**Proposed North Carolina Amendments to 2020 NEC  
Prepared by Electrical Adhoc Committee – July 7, 2020**

**Item 0: Retaining Existing NC Electrical Code Amendment, Article 10 with the modification of section 10.1 and addition of section 10.10**

**Figure 410.2 Exception Clothes Closet Storage Space Exception**

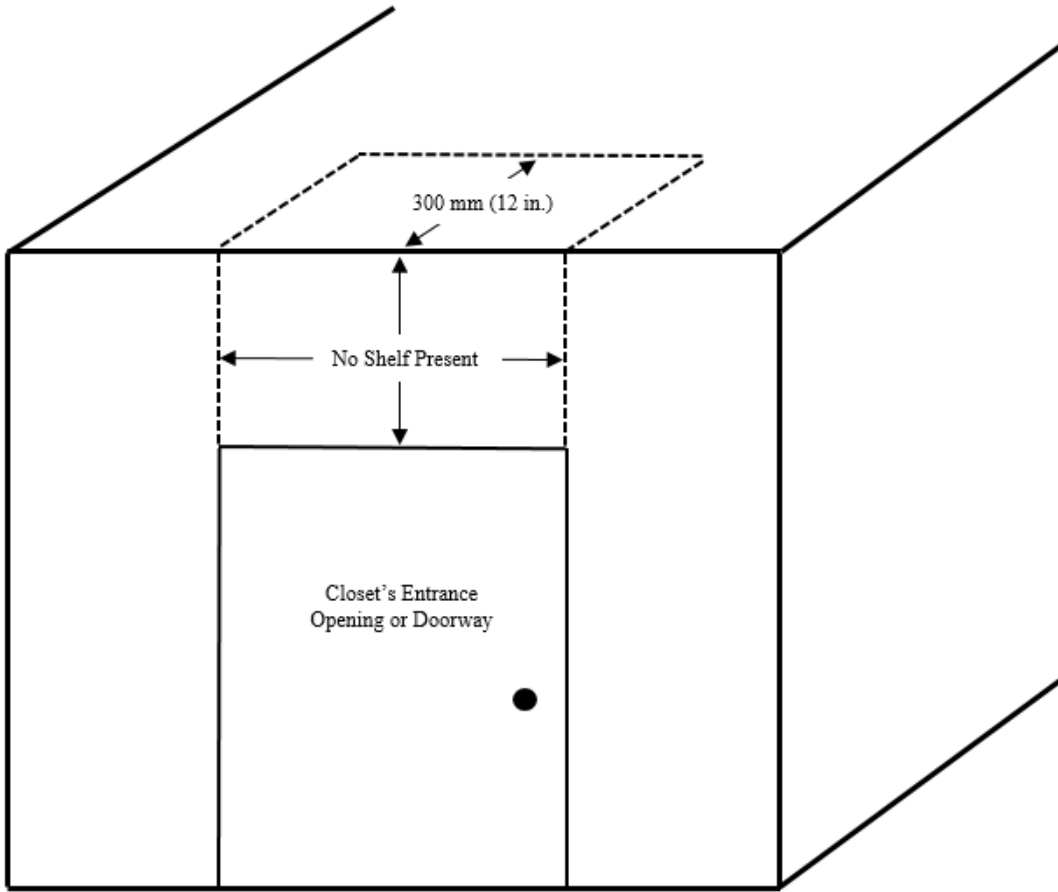
Exception: Where a shelf is not present in the area of wall above the closet's entrance opening or doorway extending from the top of such opening or doorway vertically to the ceiling, including the area of ceiling extending perpendicular from the area of wall directly above the closet's entrance opening or doorway to a horizontal distance of 300 mm (12 in.), shall not be defined as closet storage space. See Figure 410.2 Exception.
